APPLICATION NO.	FILING DATE	FIRST NAMED INVENTOR	ATTORNEY DOCKET NO.	CONFIRMATION NO.
10/574,049	03/28/2006	Cintra Jaggan-Vince	GJ-277J	7983
7590 Iandiorio & Teska 260 Bear Hill Road Watham, MA 02451				
08/20/2008				
EXAMINER				
HAWTHORNE, OPHELIA ALTHEA				
ART UNIT		PAPER NUMBER		
3772				
MAIL DATE		DELIVERY MODE		
08/20/2008		PAPER

Office Action Summary

DETAILED ACTION

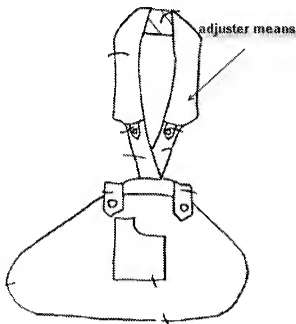
Regarding claim 2, O'Brien discloses an adjuster means (**see image below**) for adjusting the sling portion with respect to the support portion and thereby to enable the arm of the user to be supported in an optimum comfortable position. Note: it should be noted that examiner considers the strap to be the adjuster means since the strap can be lengthen and/or shorten according to the user's comfort level.

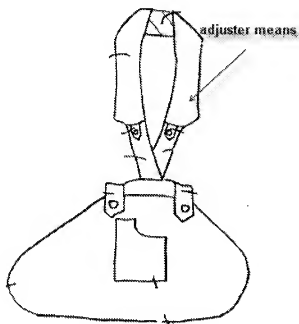
Regarding claim 13, O'Brien discloses the adjuster means is an adjuster means which extends obliquely (see image below) with respect to the longitudinal axis of the user whereby the shoulder of the user from which the arm extends is given support in a direction towards the user's body.

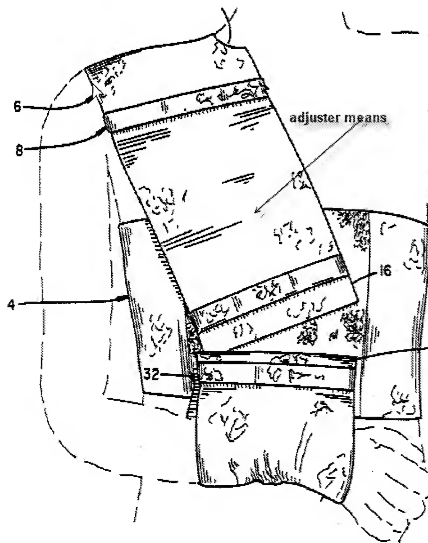
Regarding claim 4, Johnson discloses the fastener means **(32)** and the adjuster means **(see image above)** are separately formed from each other.

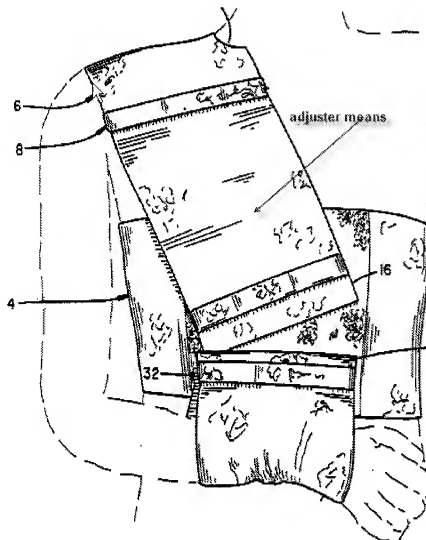
Regarding claim 13, Johnson discloses the adjuster means is an adjuster means which extends obliquely **(see image below)** with respect to the longitudinal axis of the user whereby the shoulder of the user from which the arm extends is given support in a direction towards the user's body.
